Civic Athletic Complex Master Plan – WMTP Feedback

November 20, 2024

Option 1:

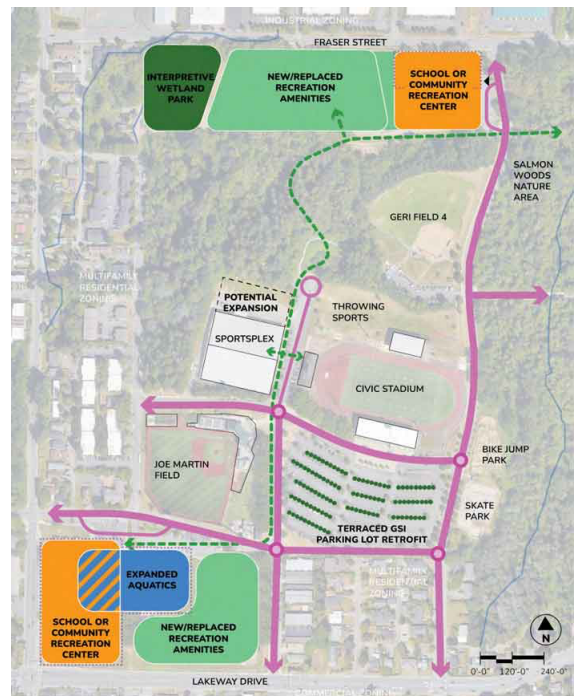
1) Option 1's northeast corner location is only reasonable for a school, not a community center. Why? A community center there would be too remote to synergize with the Aquatic Center and non-ballfield open recreational amenities. Secondly, the community center would bring continuous high car traffic onto Puget St., possibly creating the need (now or later) for signal lights at the Lakeway/Puget intersection, which is very close to the already very busy/congested Lakeway/Lincoln intersection.

2) Option 1 locates new/replaced recreational amenities along Lakeway, which is very undesirable due to high noise and air pollution levels from Lakeway traffic. Other options provide better locations for these amenities.

(3) Due to school traffic needs, a signal intersection at Puget/Lakeway would likely be required to facilitate left turns.

Terracing the Civic Field parking lot to mitigate runoff is a fine idea. Please keep in mind that that large parking lot also has enormous potential for solar parking canopies, which many cities nationally are implementing to convert (and shade) large parking lots. The solar could directly power (or at least offset a portion of the power needs) the adjacent civic facilities. It's also an opportunity for the City to provide

more community solar. With extreme summer heat effects becoming an increasingly critical issue, shade solutions (trees and/or solar canopies) will be critical to bring down the summer temperature of the entire complex and adjacent neighborhood.

Option 2:

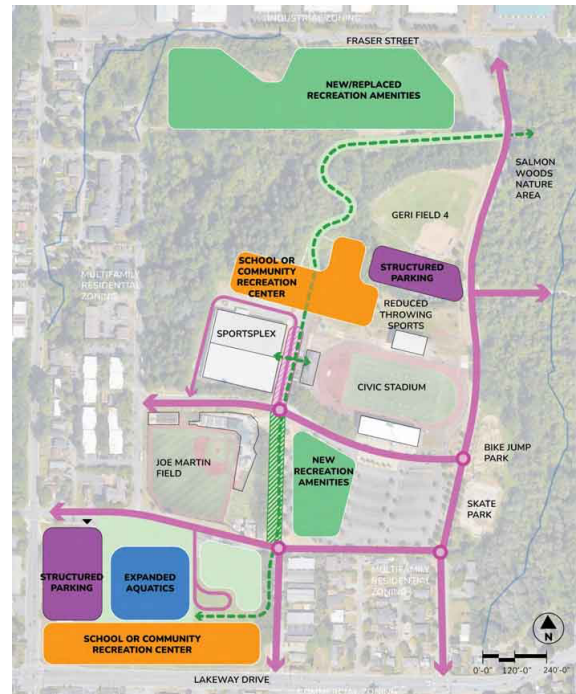
1) Option 2 pulls more vehicle activity into the center of the complex. This is a recipe for periodic traffic congestion and may discourage pedestrian/bike circulation through the center of the site.

2) We applaud that the City has largely preserved the central mature forest within the Civic Athletic Complex from becoming a facility site. That forest area contains many Landmark Trees. If Option 2 is pursued, we hope its detailed design will preserve all healthy Landmark Trees on the site rather than remove some of the trees and try to offset that loss with new tree plantings, which won't truly begin to offset the loss for many decades. The City should follow the same rules in its public developments that are required of residents and private developers.

3) Option 2's pedestrian "framed gateway" through the middle of the new building is problematic. "Framed gateway" is architect jargon -- for everyone else this is essentially a wall and tunnel. If the location is used for the new school, it likely could not meet school site security needs, especially during a lockdown event. The location is also weak for synergy potential of school programs/kids with the new community center located near the southwest corner of the complex. If the mid-site location is instead used for the community center, the center plus the proposed adjacent parking garage will still visually wall off the north end of the complex, which is undesirable for many reasons.

4) Option 2's mid-site location disconnects the school (or community center) from the urban fabric of the community. We believe that would be a mistake. Isolation of that site is not desirable, especially off-hours.

5) The long, linear proportion of the Lakeway corner location is only potentially feasible for a community center, not an elementary school. But it's still not ideal even for a community center.

6) As the presentation identified, this Option may limit expansion of the Sportsplex.

7) Due to school traffic needs, a signal intersection at Puget/Lakeway would likely be required to facilitate left turns.

Option 3:

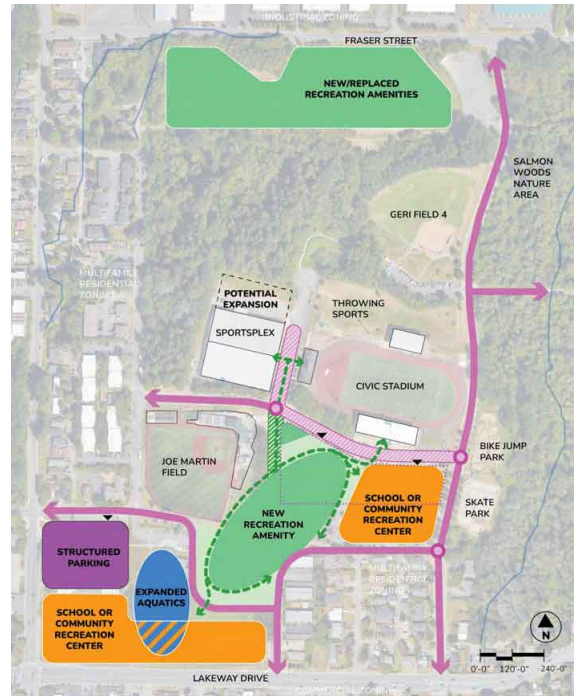
(1) Due to school traffic needs, a signal intersection at Puget/Lakeway would likely be required to facilitate left turns.

(1) Option 3 creates a potentially world-class collective open space with pedestrian linkages into all surrounding facilities. It is the only option that feels visionary in its design potential. It goes beyond merely fitting the new facilities in available locations.

(2) Option 3 appropriately keeps higher volume vehicle circulation towards Lakeway instead of into the central or north areas of the site.

(3) A school located as shown in the southern portion of Puget Street allows an appropriate area and site shape for the school. The location also is an appropriate balance of staying away from Lakeway (noise and pollution) but not being as far as Option 1's northeast corner of the complex.

(4) Option 3 honors the integrity of the retained central forest area, even if some Sportsplex expansion eventually occurs.

(5) Option 3's tuck under parking, while more expensive, is a great way to solve parking needs yet also meet recreational requirements of artificial turf fields.

Option 4:

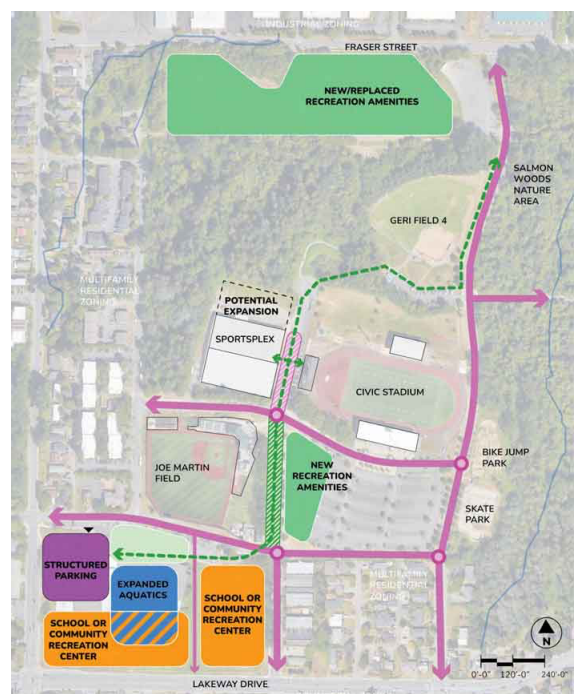
(1) Option 4 underperforms in terms of tying the entire complex together into a diverse but cohesive whole. Perhaps a variation of Option 4 could better address that.
